**DODDRIDGE COUNTY COMMISSION
DODDRIDGE COUNTY, WEST VIRGINIA**

**DODDRIDGE COUNTY ADMINISTRATIVE ANNEX
WEST UNION, WEST VIRGINIA
THRASHER PROJECT #060-0981**

**ADDENDUM #2
March 25, 2021**

SHEET No.
C4.00

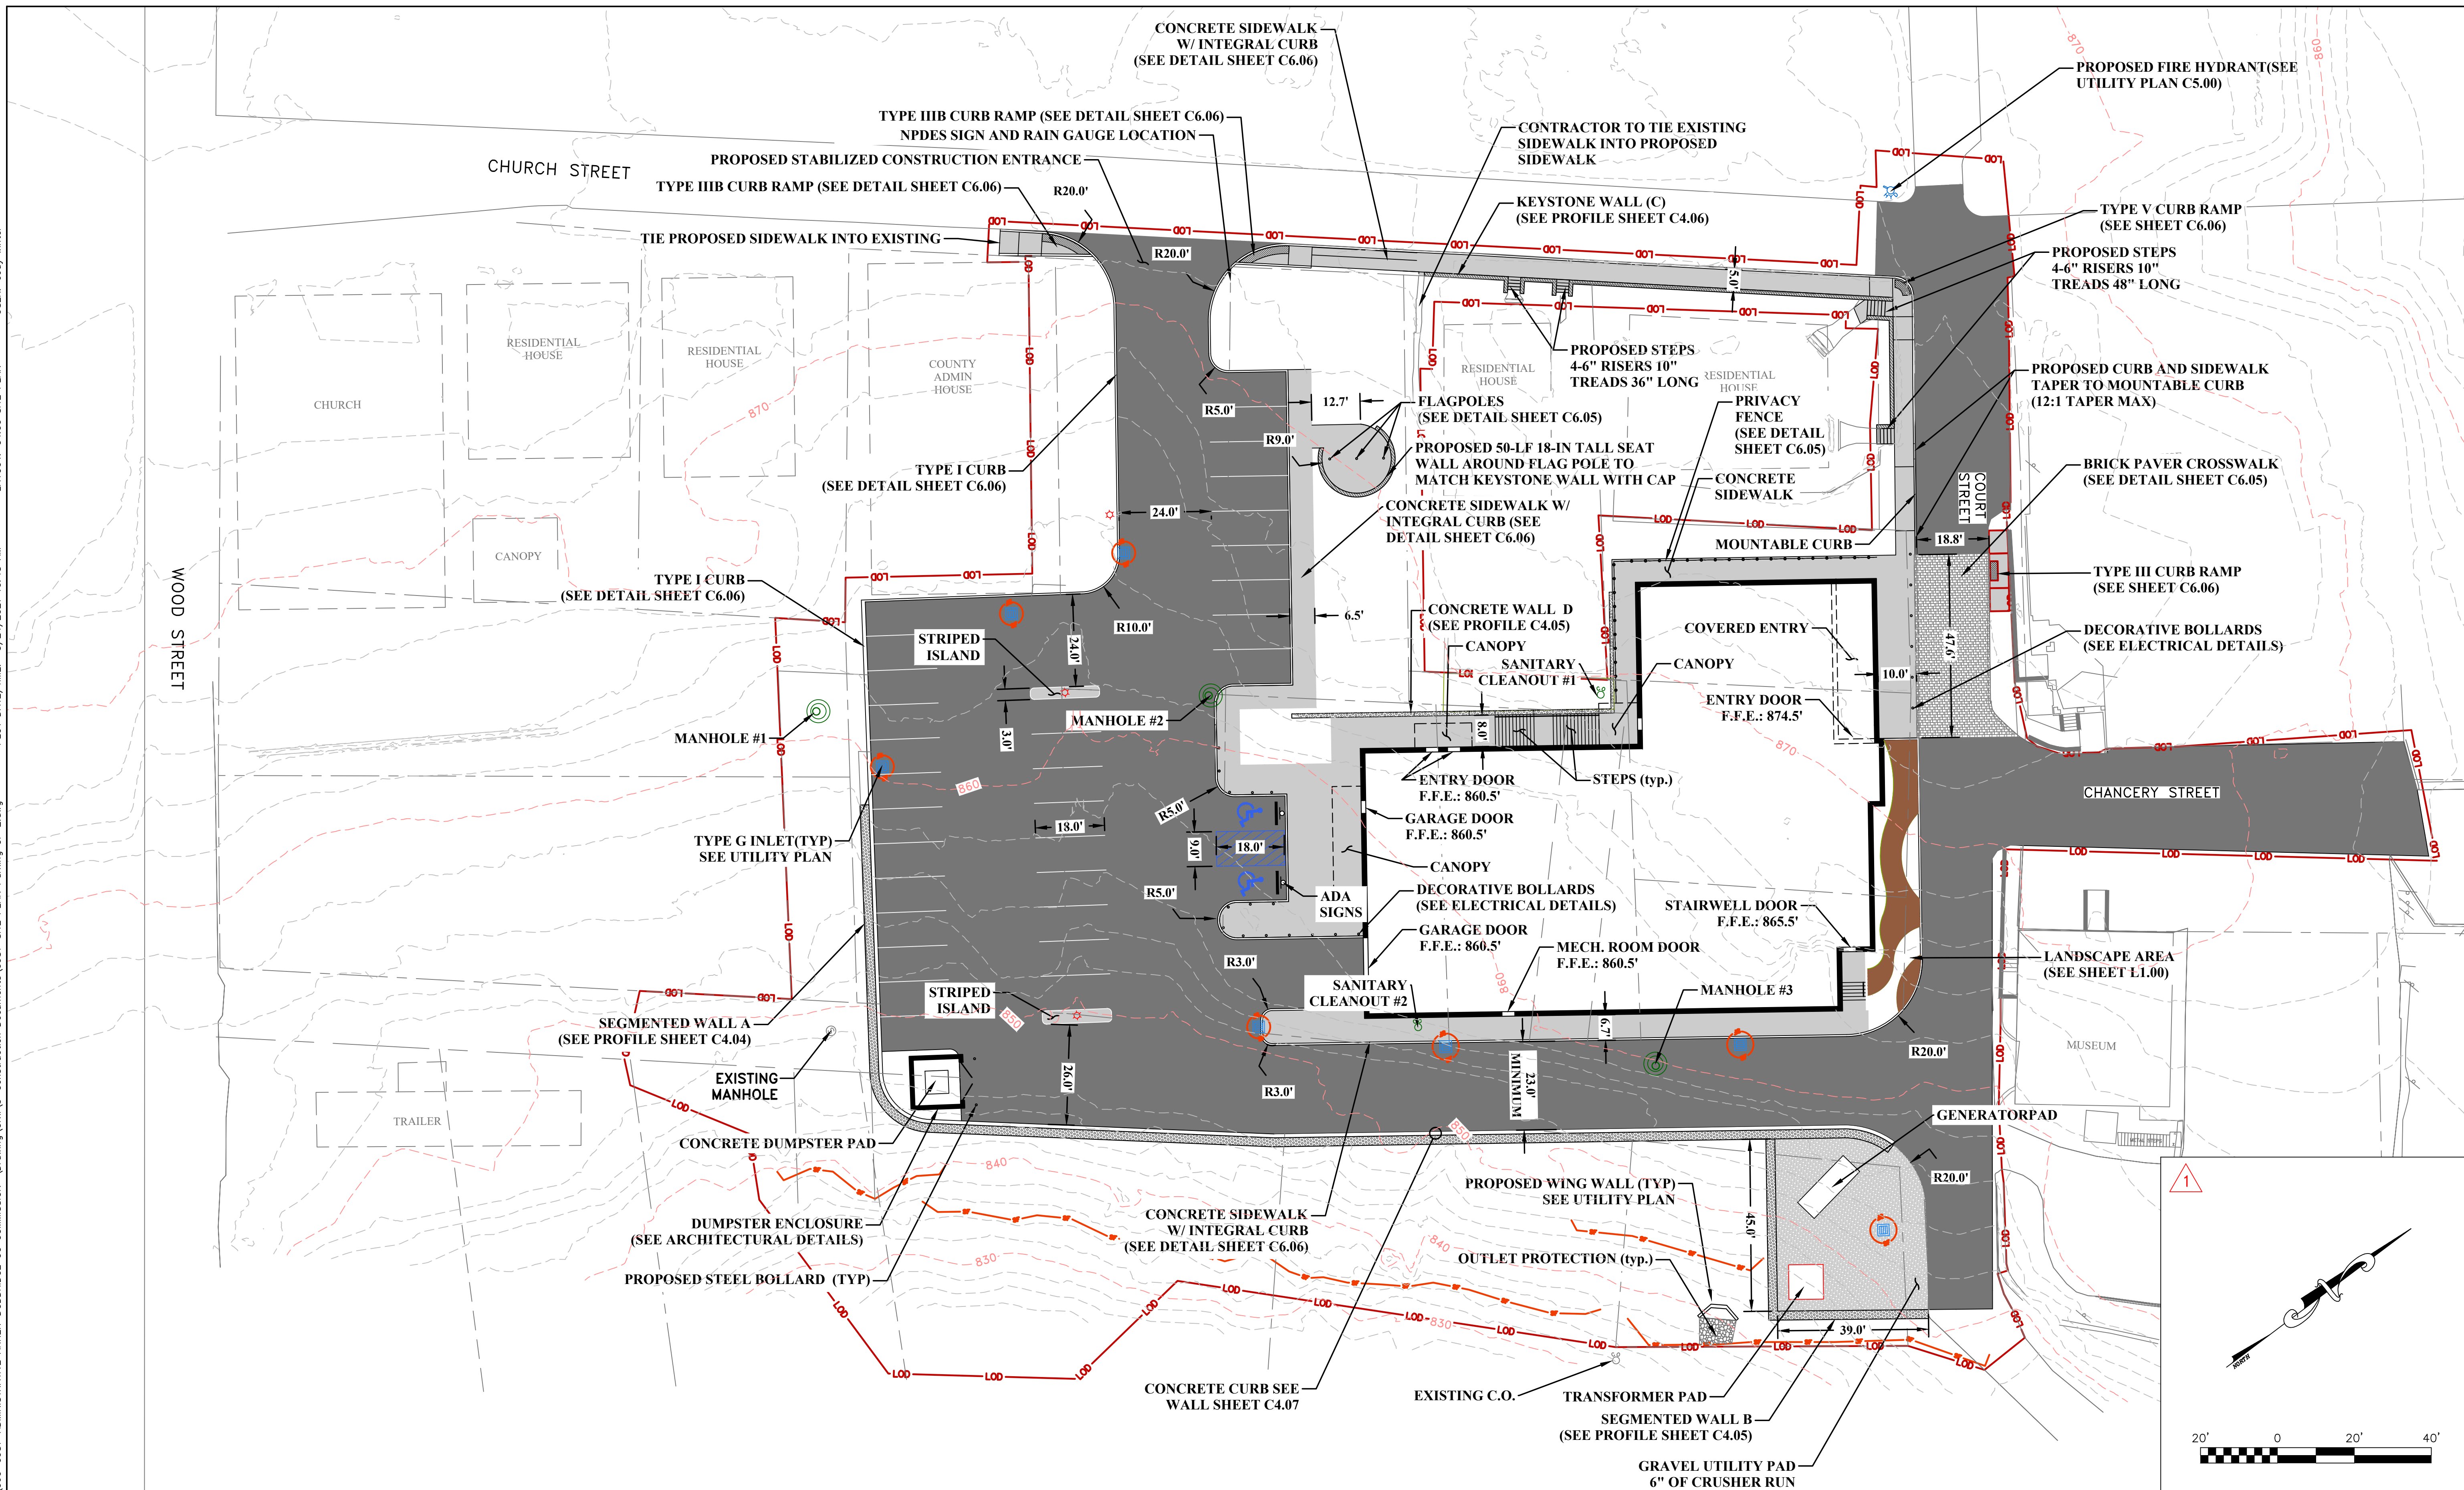
NO.	BY	DATE	DESCRIPTION
1	CRW	3/24/19	UPDATED DRAWING WITH CORRECT SURFACE

SHEET No.
C4.04

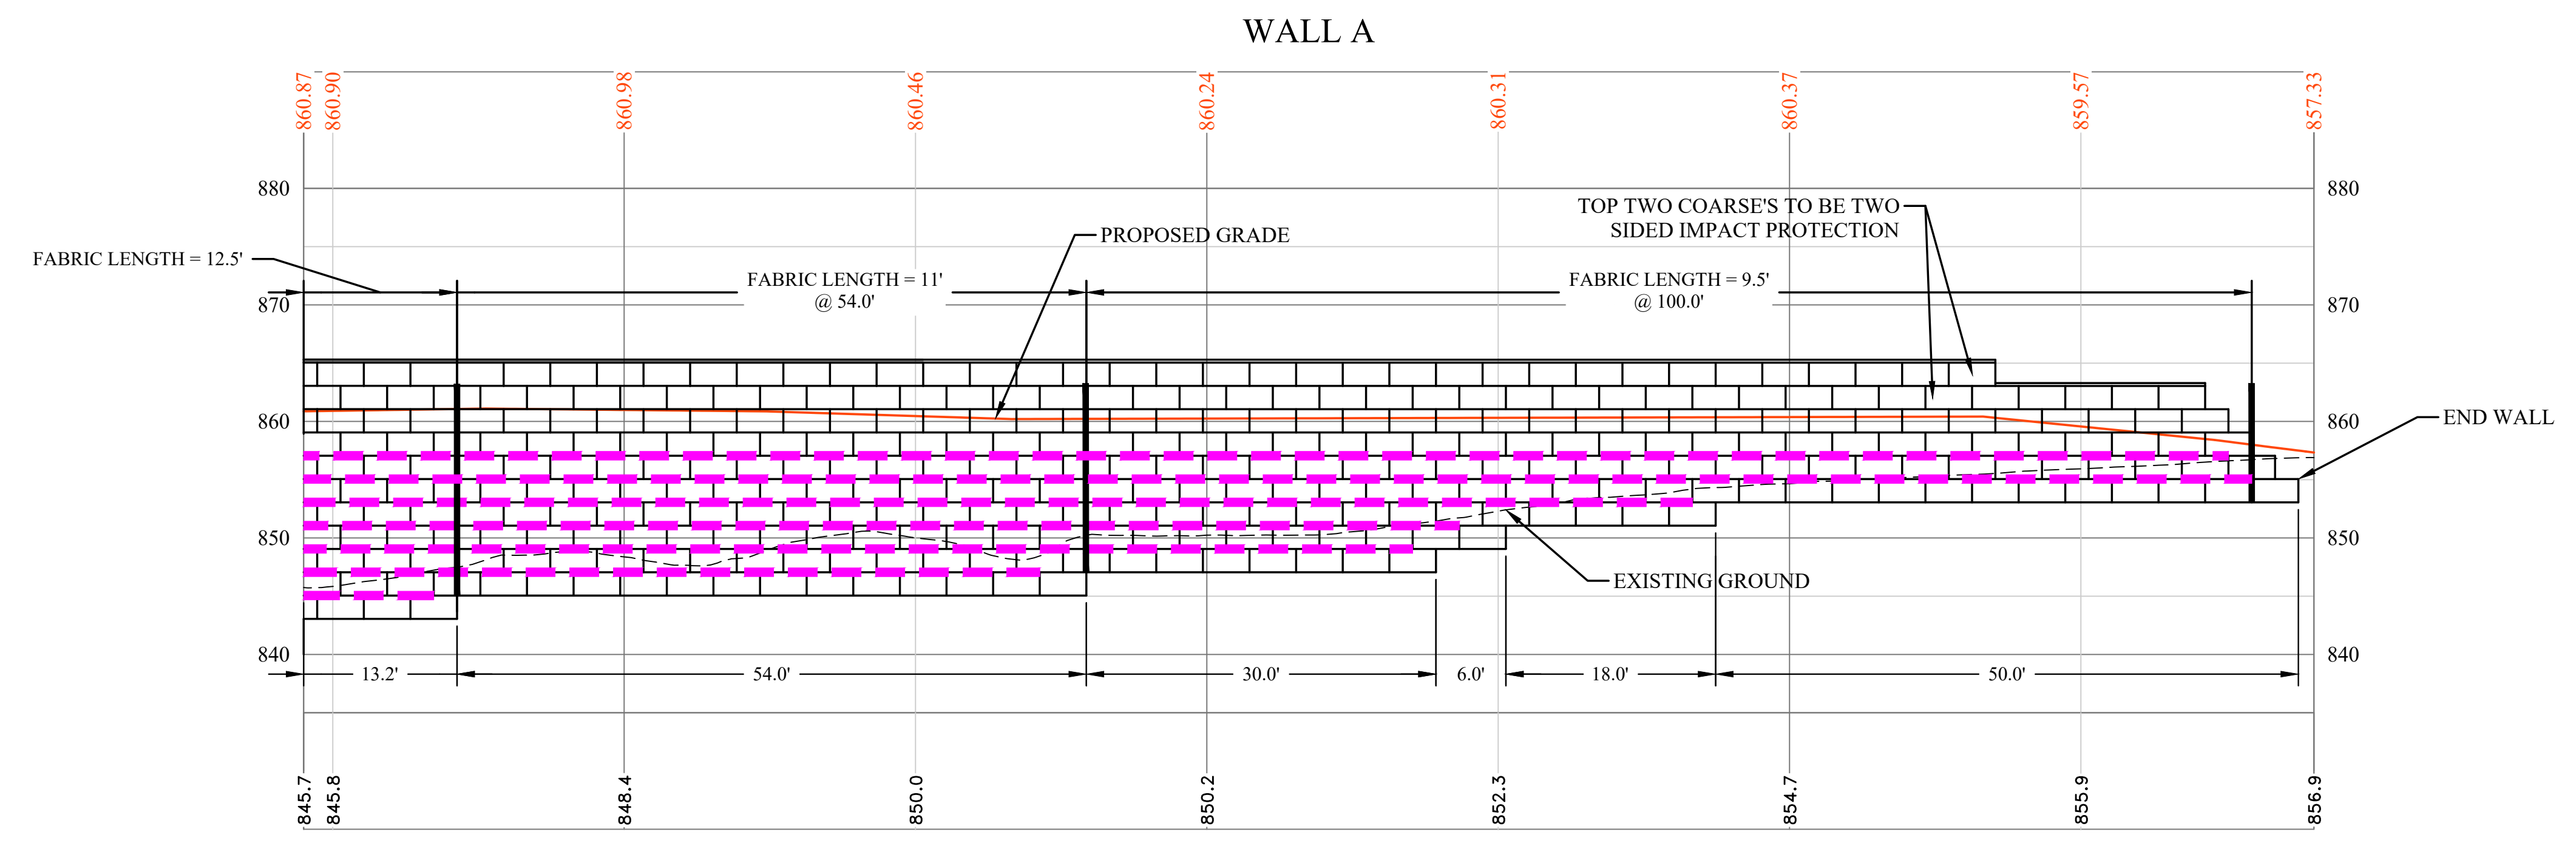
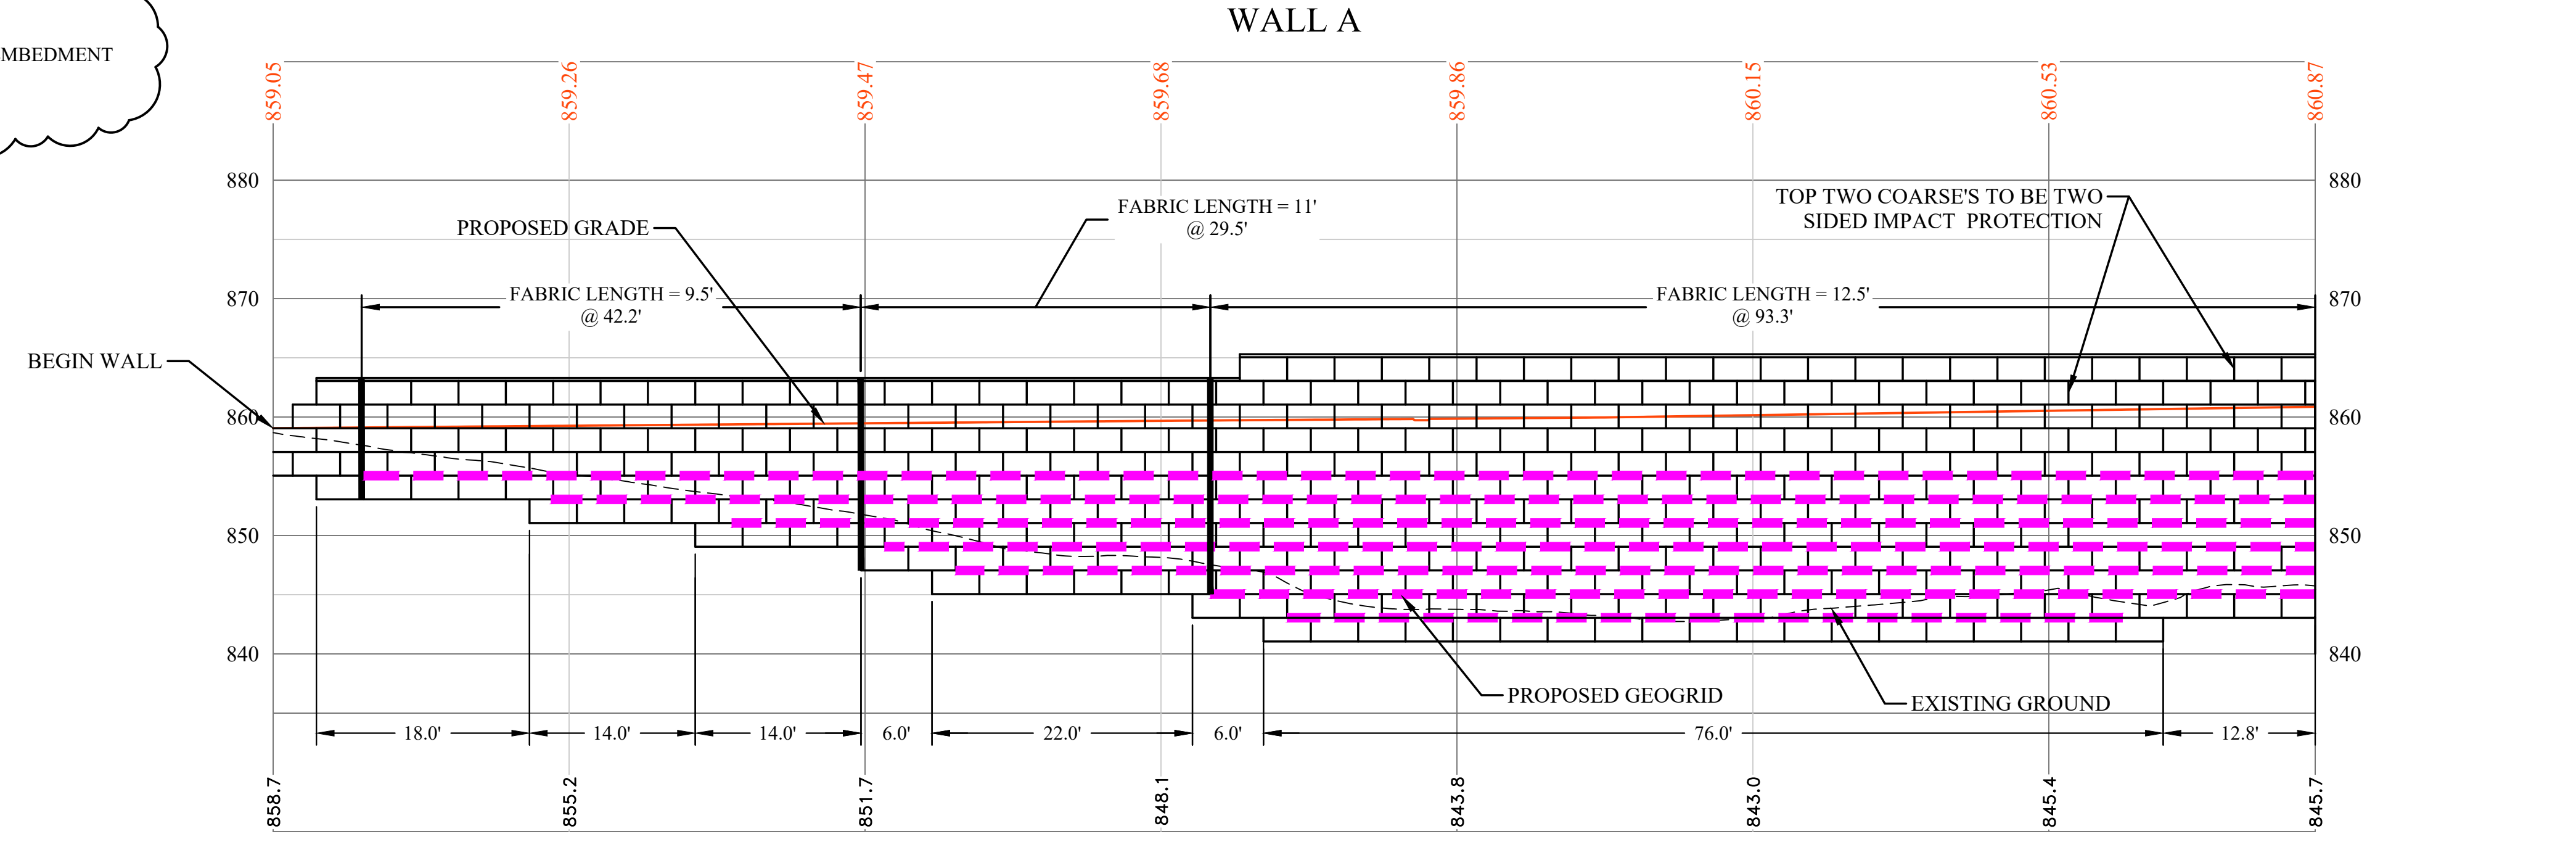
1. Reference drawing sheet SE1. See attached sketches SKE-1, SKE-2 and SKE-3 for details on electrical services to the Courthouse and Jail/Museum.
2. 1.Reference drawing sheet E4.01. See ELECTRICAL RISER. Omit CT Cabinet and Meter. Power company will meter at the power company transformer. Omit Riser Note "B". Conduit and feeder from the power company transformer will go to the ATS.
3. REPLACE SHEET C4.00 SITE PLAN
4. REPLACE SHEET C4.04 WALL PROFILE
5. REPLACE SHEET C5.00 UTILITY PLAN

1 MODIFIED WALL HEIGHT AND EMBEDMENT

NO.	BY	DATE	DESCRIPTION
1	BD	3/25/2021	WALL EMBEDMENT AND HEIGHT ADJUSTMENTS
